Ref. No. : MCHI/PRES/17-18/216

Subject:- Suggestion / Objections and Request for Hearing in respect to Draft Notification published on 12th April 2018 to amend the existing GSR 751 E, Ministry of Civil Aviation (Height Restrictions for Safeguarding of Aircraft Operations) Rules, 2015

NOTE ON DISPALCED THRESHOLD ANALYSIS

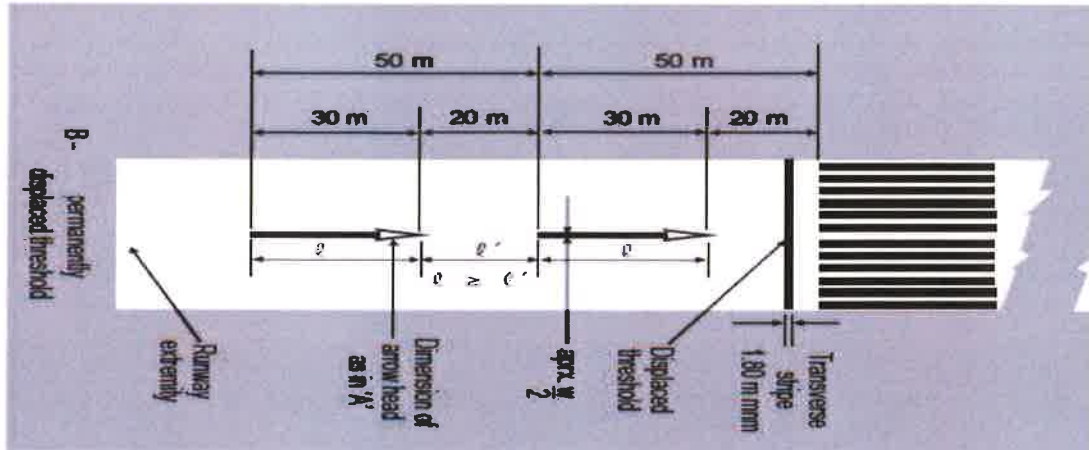
f) EFFECT ON PAN OPS PROCEDURE: VISUAL SEGMENT SURFACE: (ICAO, Document - 8168, Volume 1)

- New straight-in instrument approach procedures published on or after 15 March 2007 shall be protected for obstacles in the visual segment. For this purpose, no obstacles, except subject to 5.4.6.4, shall penetrate a Visual Segment Surface (VSS) laterally.
- (5.4.6.4: If the VSS is penetrated, the approach procedure should not be promulgated without an aeronautical study. Mitigation action as a result of such a study may result in an increase of the descent gradient/angle and/or runway threshold displacement)
- ILS Glide Path angle for runway 14 is 3 degree (AIP- AD2.22 VABB) and the required for VSS is 1.88 degree ($3^\circ - 1.12^\circ = 1.88^\circ$).
- The Percentage of required slope is 3.3% (1:33.33)

- ILS Glide Path location, reference datum and determined obstacle clearance limits for Mumbai Runway 09/27/14 are based on threshold location (Displaced).
- Portion of objects which are covered under VISUAL SEGMENT SURFACE in accordance with the provision i.e., starting 60m from displaced threshold (shifted approach area) are being analysed for transitional surface requirement of slope 14.3%(1:7).

Hence, the required obstacle protection slope of 3.3%(1:33.33) for VSS area is not protected which is a safety hazard as the obstacle are not protected or limited in respect to threshold (Displaced).

- k) We therefore request following amendment for consideration in the GSR 751 (E), Para 1.3.1.4: "In case the threshold has been displaced due to Obstacles of Permanent Nature, which are in existence for considerable time, not likely to be removed or no scope for runway extension and Instrument Approach Landing Procedure are permanently established at the aerodrome with the threshold reference, the Threshold (Displaced) shall be considered as reference point" for NOC calculation

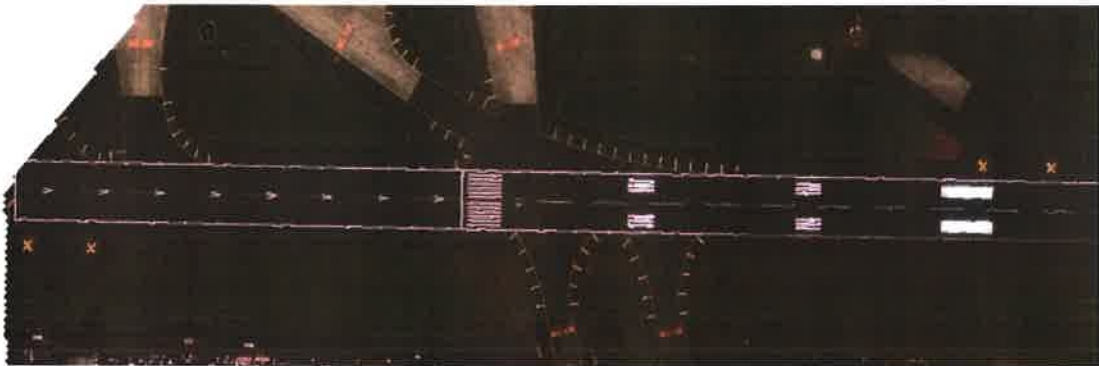
- The threshold is normally located at the extremity of a runway, if there are no obstacles penetrating above the approach surface.
- The major ends (Extremities) of all the runways at Mumbai International Airport and Juhu airport are having obstacles penetrating the approach surface and cannot be removed.
- 09 / 27 – Railway Track Lines, Buildings constructed prior to the inception of the airport. 14 / 32 – National Highway, Buildings constructed prior to the inception of the airport. Juhu 08 / 26 – Buildings constructed prior to the inception of the airport.
- As per Annexure 14 of ICAO, when the runway threshold is permanently displaced, the longitudinal strips are placed after the transverse stripe as shown below.

- In the below satellite image (IKONOS - II) for the CSI Airport, Mumbai, it is observed that the marking on the Runway 14 is same as given in Annexure 14 "Aerodromes" for permanent displacement, hence it is clear that the thresholds is permanently displaced from respective extremity of the runway.
